## COMMISSION OF ARCHITECTURAL REVIEW STAFF REPORT July 25, 2017, Meeting

**3. COA-019814-2017** (T. Innes)

2201 East Marshall Street Church Hill North Old and Historic District

Project Description: Replace front porch roof with gray TPO.

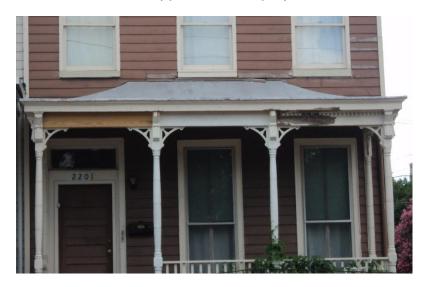
The applicant requests approval to replace the front porch roof of this single family Italianate home in the Church Hill North Old and Historic District. The applicant states that the current flat seam tin roof needs to be replaced and is proposing to install a gray TPO membrane.

Staff recommends approval of the project as submitted. The Richmond Old and Historic District Handbook and Design Review Guidelines note that substitute roof materials may be used if the same kind of material is no longer being made, but substitute materials should match the original style and form as much as possible (p. 64, #3). The applicant states that the flat seam tin roof is no longer available and the roof needs to be replaced because leaking water is causing damage to the porch. There is evidence of damage to the woodwork. As the proposed gray TPO membrane will match the original flat seam roof in appearance, staff recommends approval of the project as submitted.
